Market Change Request

Number		Title	Priority
MCR	0156	Amending Generator Unit ID and Generation Unit ID	<i>High</i>

Date	Version	Reason For Change
19/10/2007	1.0	Market Change Request raised containing no changes from the associated Discussion Request.

CHANGE REQUEST:			
Name of Requesting Organisation		RMDS	
Contact name		Richard Bloomfield	
Date Change Request Raised		19 th October 2007	Originating Discussion Request
		DR	0151

MCR 112 Changes

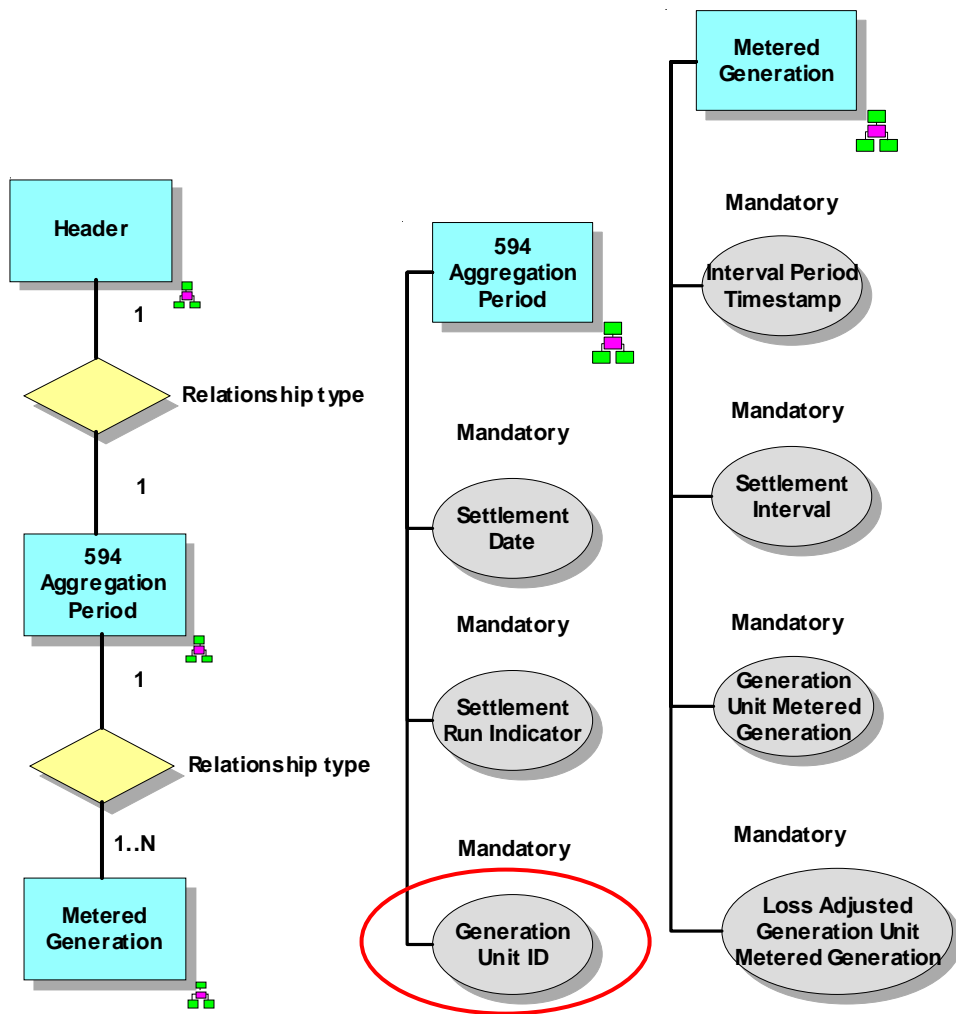
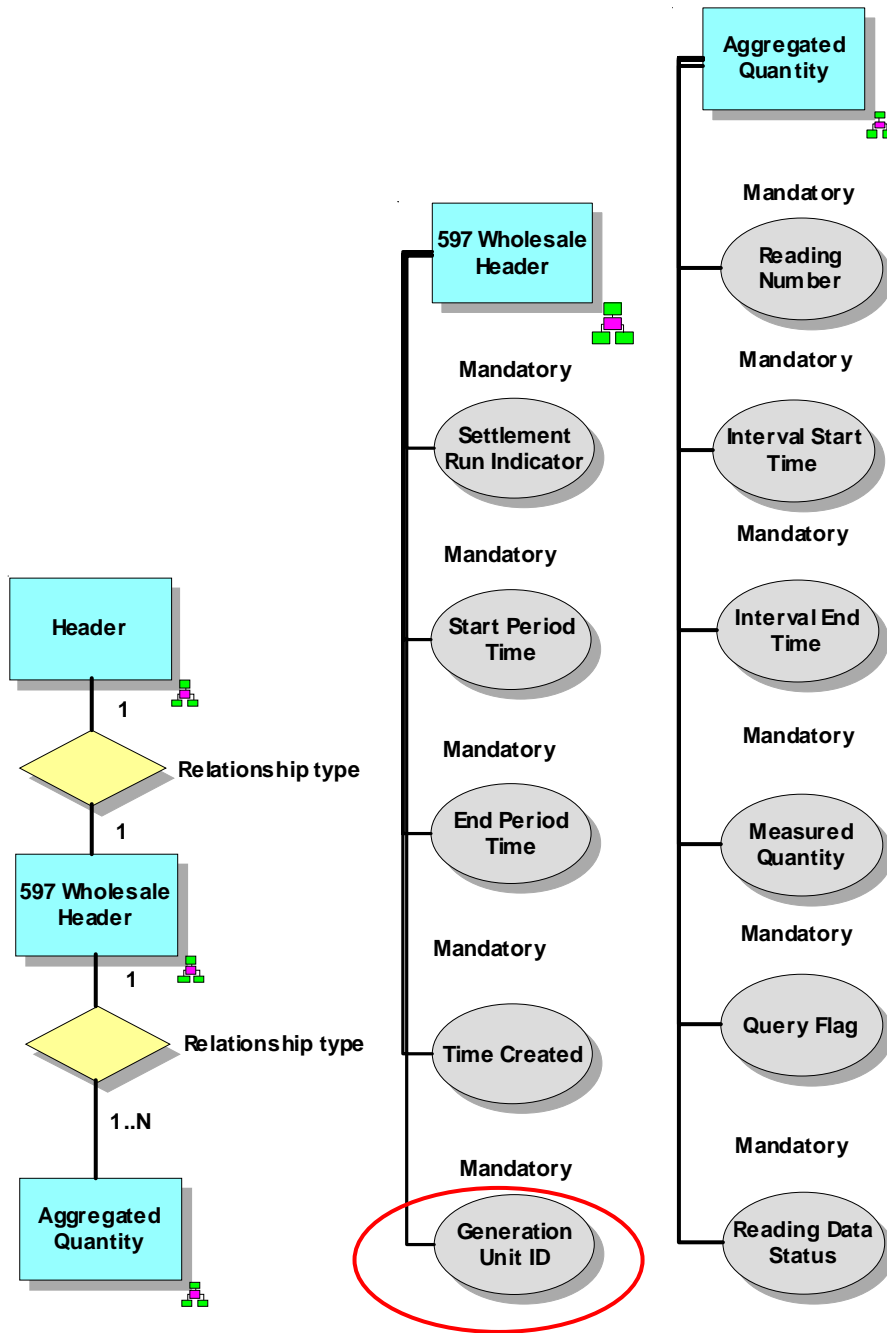
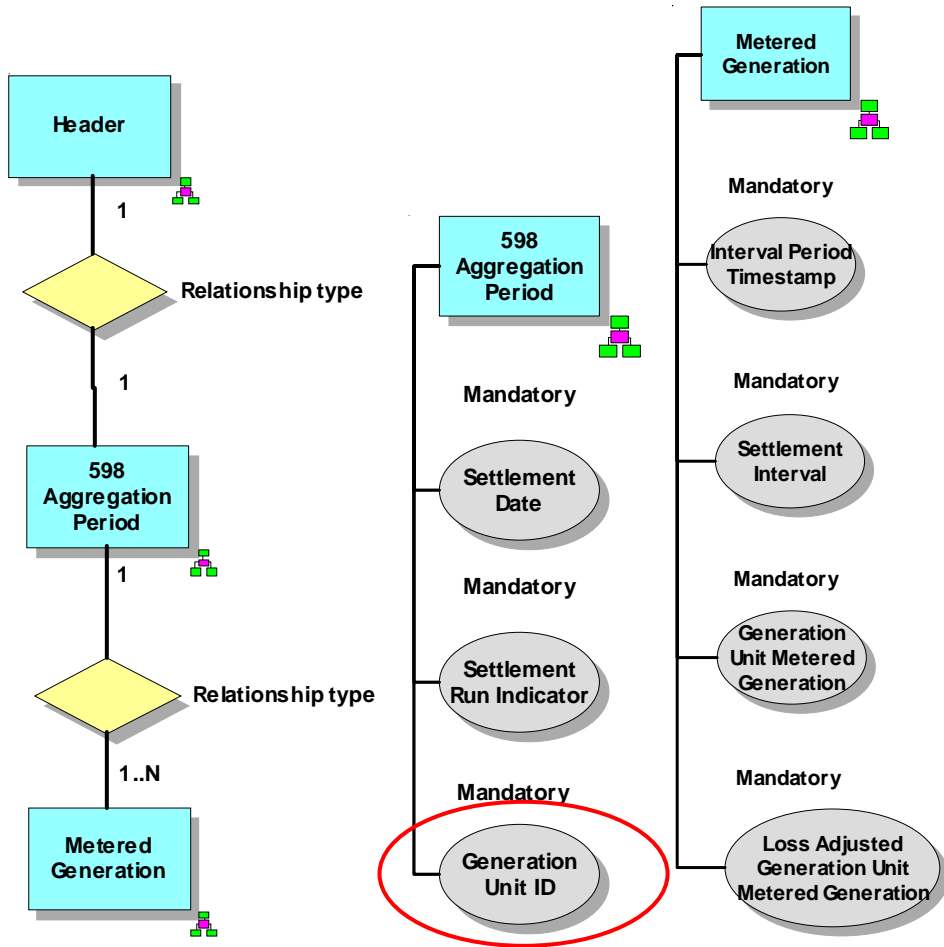
Note: Details of new Data Items and Definitions (i.e. ~~Supplier Unit ID, Generator Unit ID~~) can be

found in MCR 120.
